Yorkton Facility  
Dementia- and Age-Friendly  
Audit Photos

# Gallagher Centre – Convention Centre

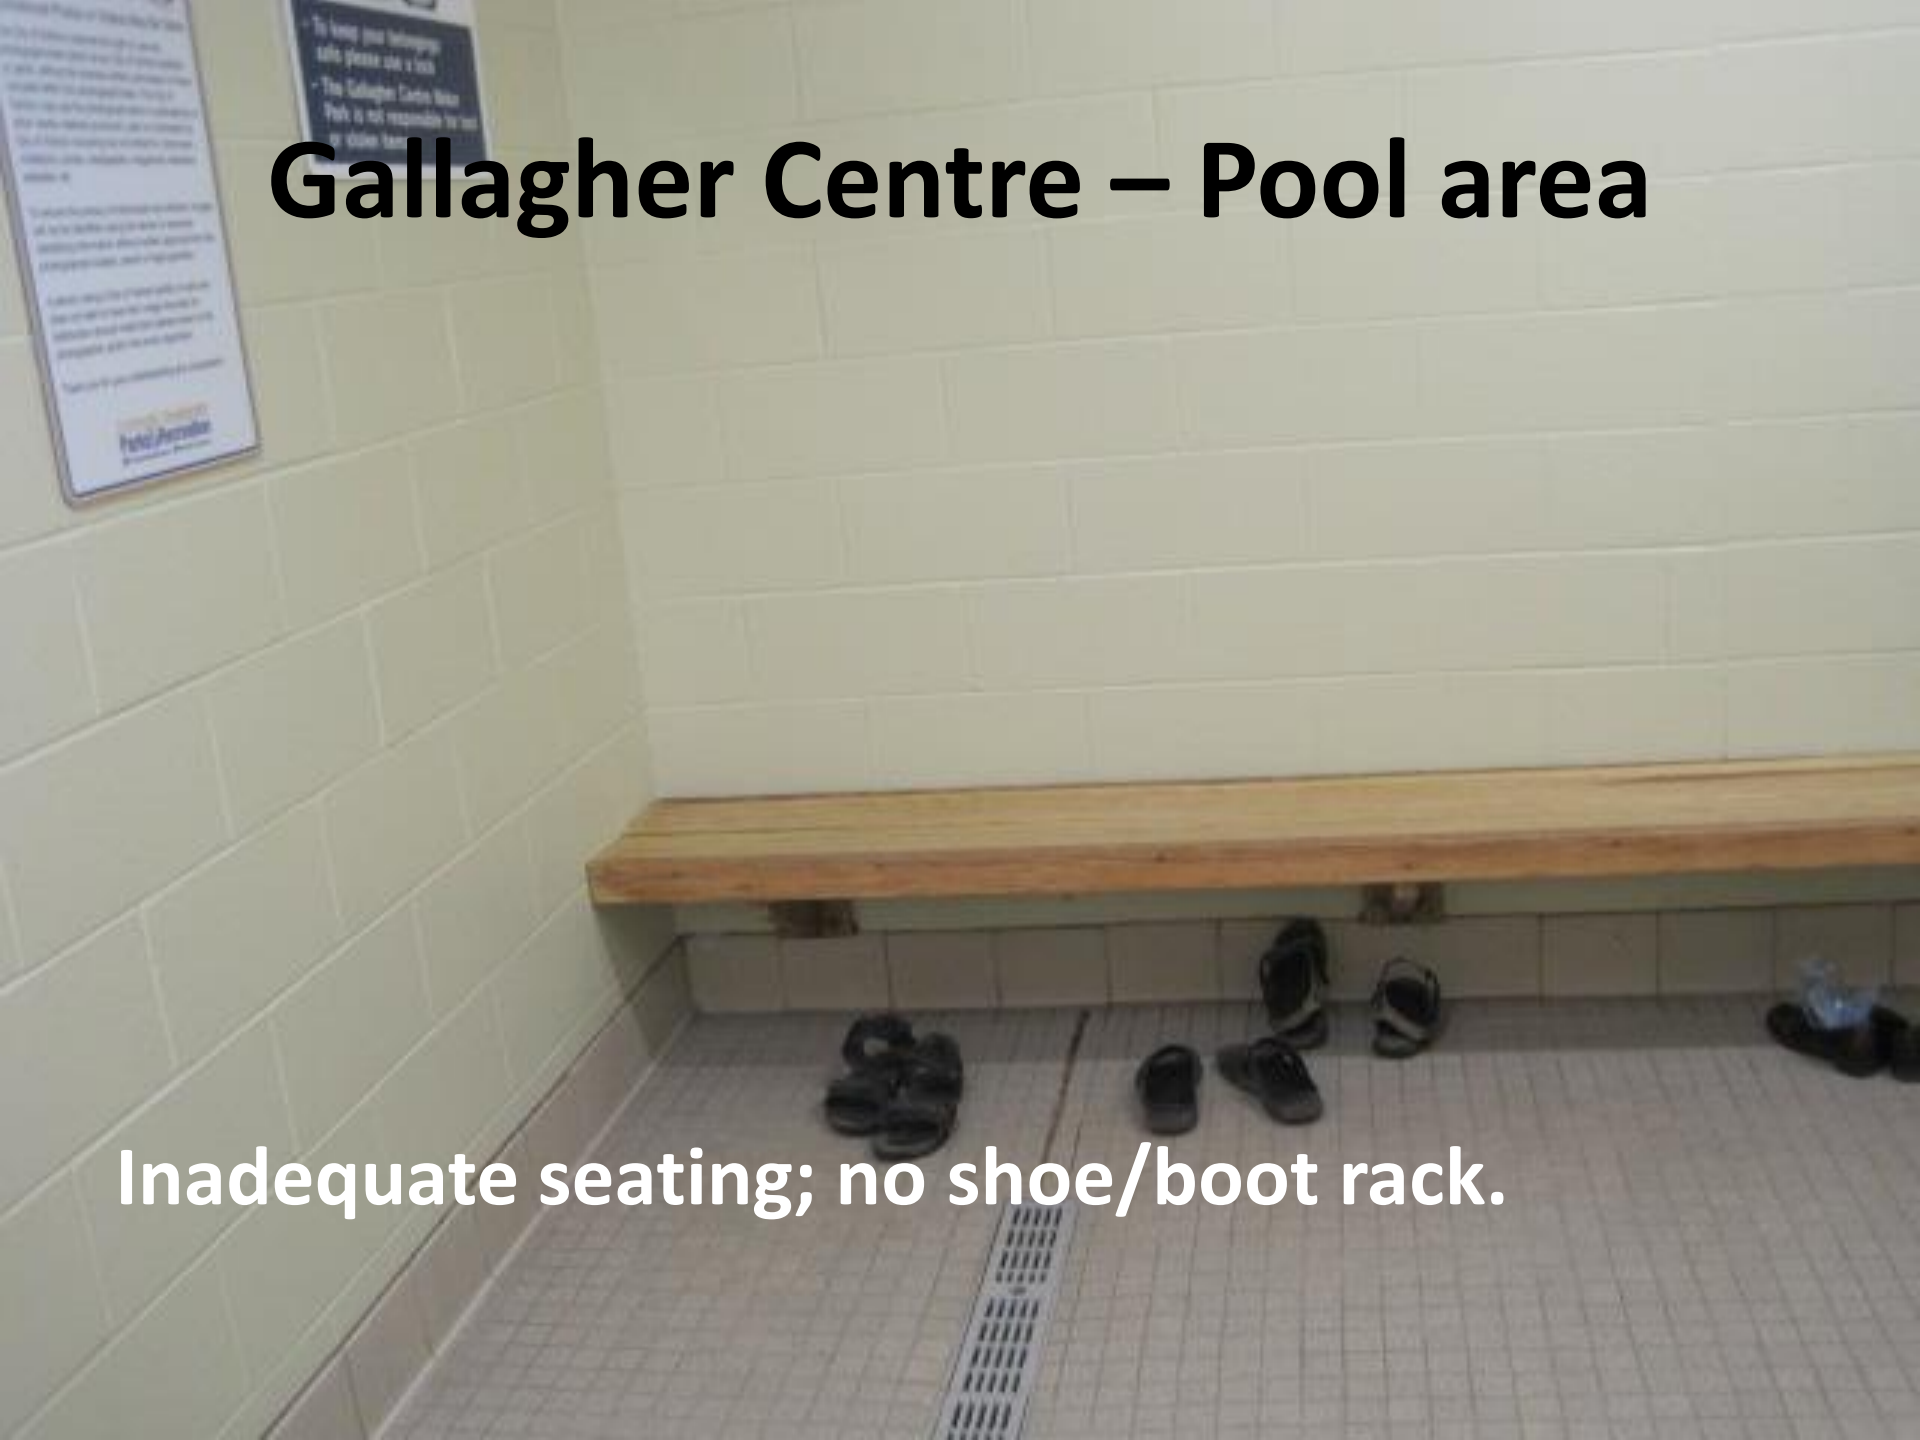
**This is the only sign indicating that this is the convention centre meeting room/event venue. Suggest more meaningful names.**

# **Gallagher Centre – Second floor**

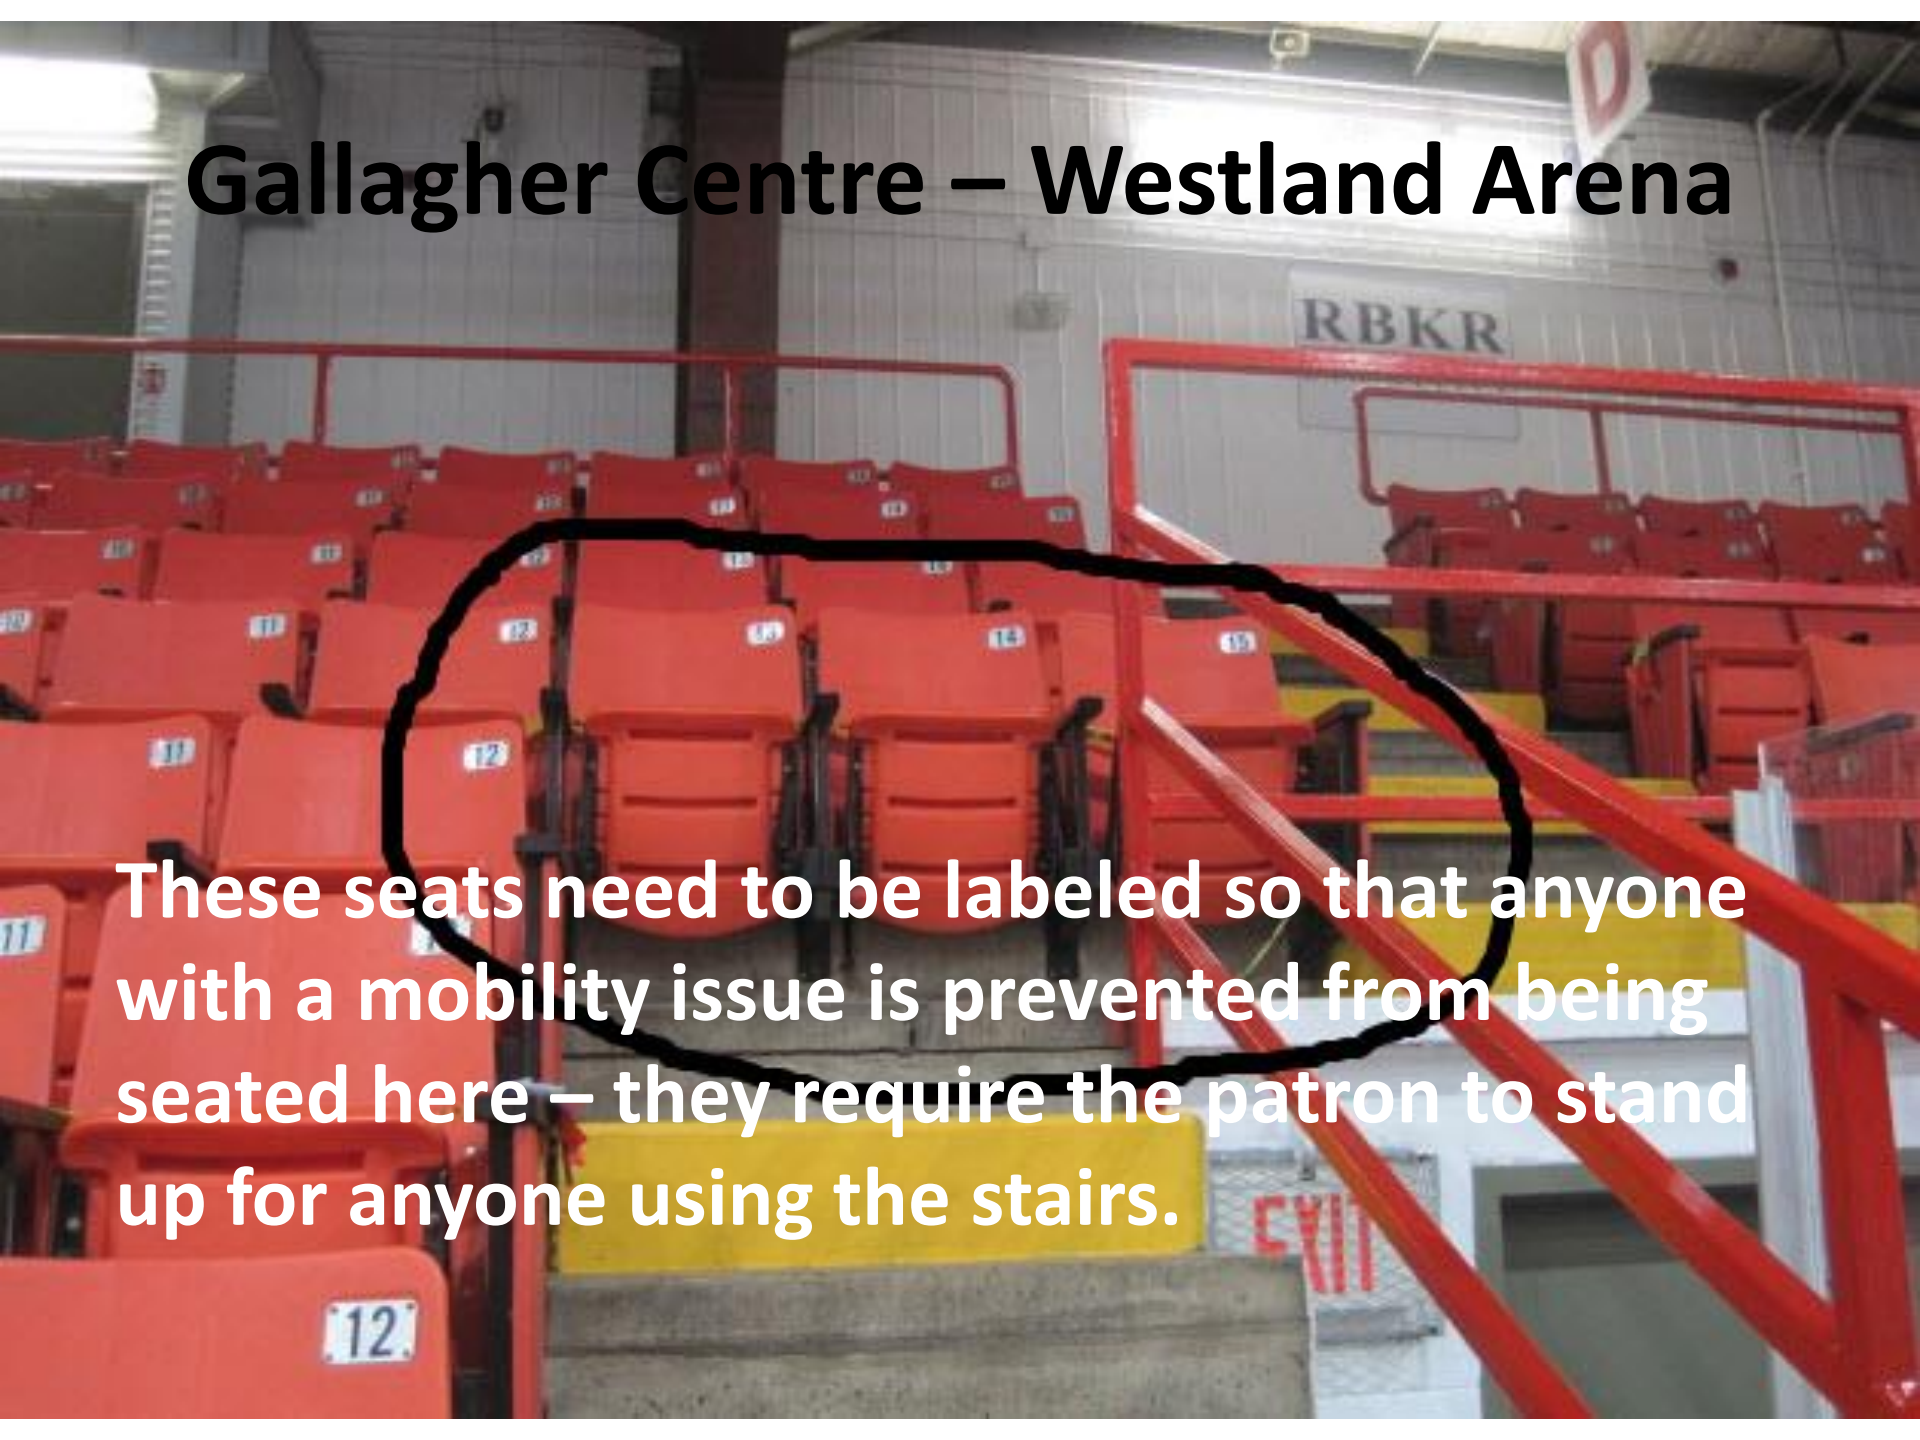
**Good sign – large, visible text with a directional arrow.**

# Gallagher Centre – Westland Arena

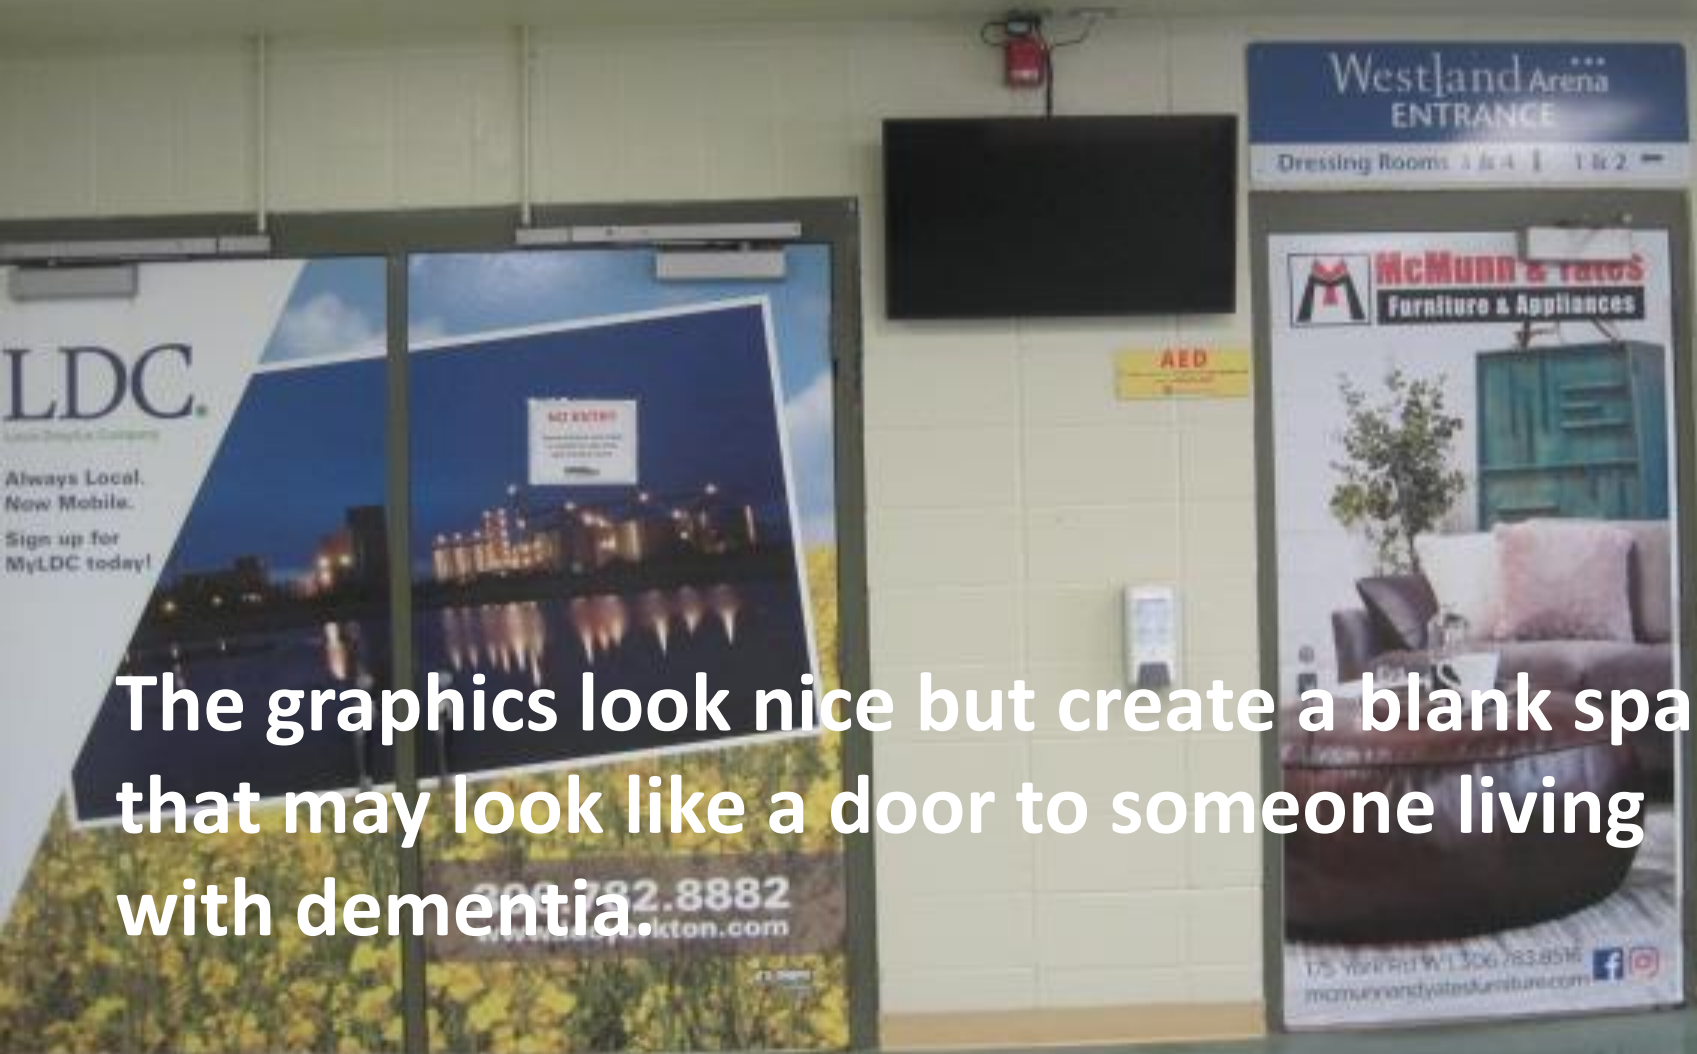
**The gutter along the rink edge is a trip hazard that should at least be painted a bright colour.**

# Gallagher Centre – Pool area

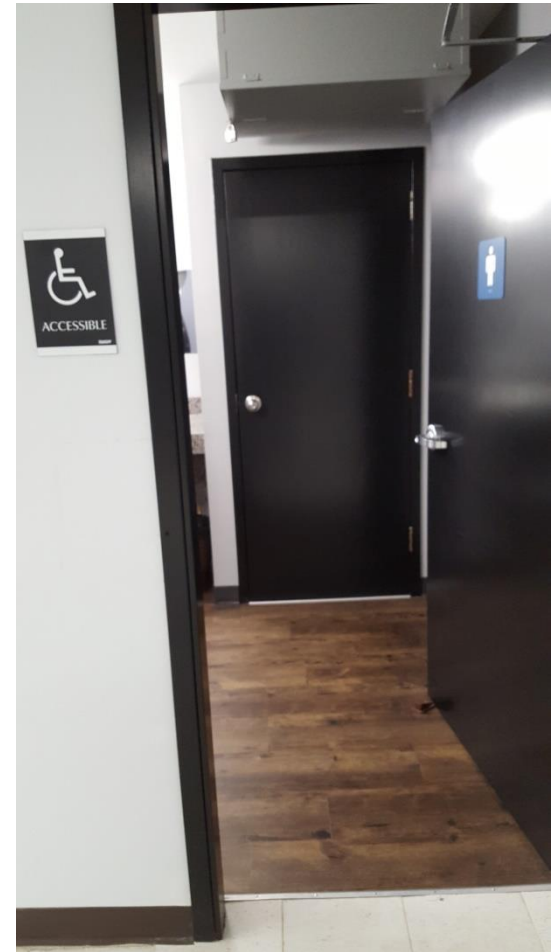
IN/OUT signs are good. Bigger would be better.
